SUBJECT: ISSUANCE OF AMENDMENT NO. 189 TO FACILITY OPERATING LICENSE
 NO. NPF-6 - ARKANSAS NUCLEAR ONE, UNIT NO. 2 (TAC NO. M99654)

AMENDMENT TO FACILITY OPERATING LICENSE

Amendment No. 189
License No. NPF-6

SAFETY EVALUATION BY THE OFFICE OF NUCLEAR REACTOR REGULATION

**CONTAINMENT INTERNAL PRESSURE vs.
AVERAGE AIR TEMPERATURE
FIGURE 3.6-1**

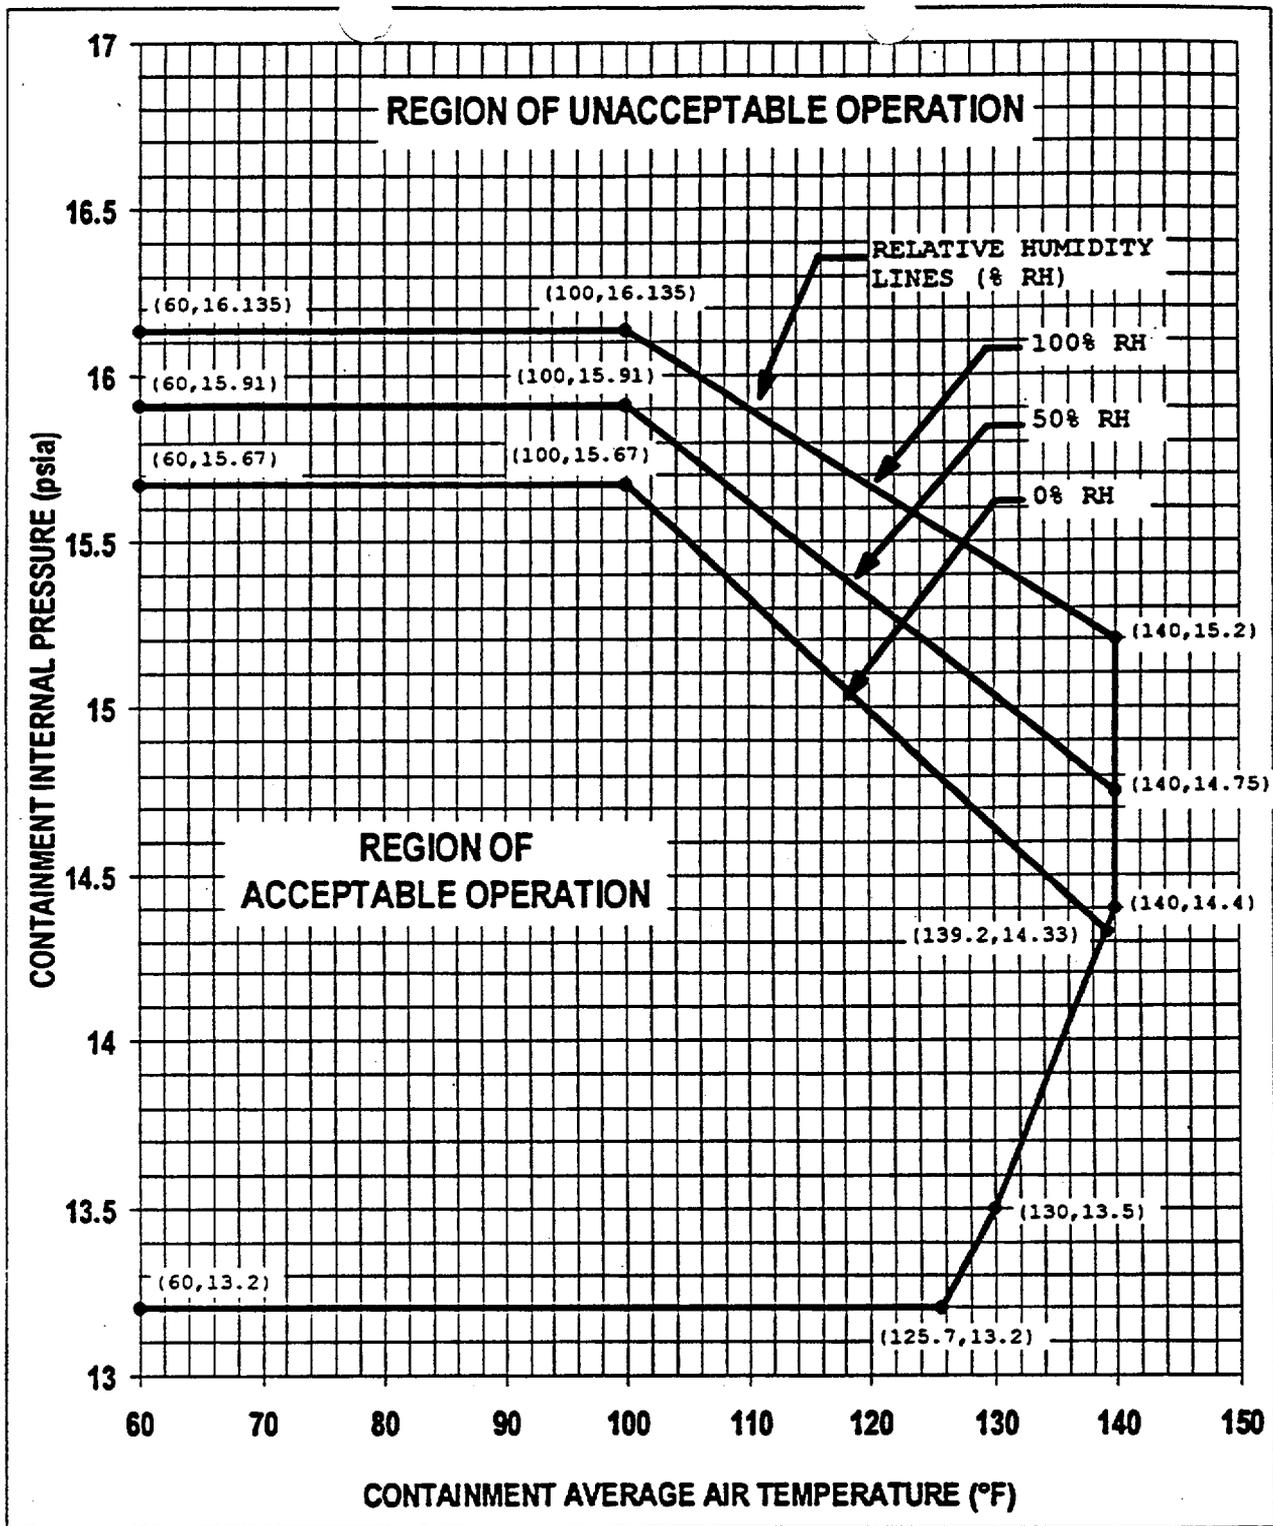
TS Figure 3.6-1, "Containment Internal Pressure vs. Average Air Temperature," is developed using the limiting initial conditions for analyses associated with (1) the loss of coolant accident evaluation performed per 10 CFR 50.46, (2) the containment design negative pressure differential of 5psid (potentially caused by an inadvertent actuation of containment spray), and (3) the containment design pressure of 54 psig following either a loss of coolant accident or secondary-side high energy line break. The licensee presented the results of a series of analyses related to containment initial conditions (pressure, temperature, and relative humidity) for the revised main steam line break conditions. The new analyses, combined with previous evaluations of the sensitivity of the containment pressure response to initial conditions for the loss of coolant accident and the limiting initial conditions for the loss of coolant evaluation model and negative pressure differential limits, resulted in minor changes to the locus of points defining the area of acceptable operation in Figure 3.6-1. The staff finds the changes to the figure are consistent with the analyses presented by the licensee and are acceptable.
